Product Change Notification

Change Notification #: 115199-00
Change Title: Intel® Server Board S2600TPR,
Intel® Server Board S2600TPFR and
Intel® Compute Module HNS2600TP24SR,
PCN115199-00, Product Material,
Replacement of BMC DDR3 chip
Date of Publication: December 21, 2016

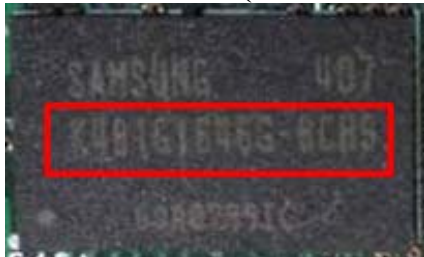
Intel is replacing the current BMC DDR3 memory chip K4B1G1646G-BCH9 (G38649-001) (end of life) with new K4B1G1646I-BCK0 (J37656-001). Intel reports validation completed with passing results. The replacement component is identical in form, fit and function.
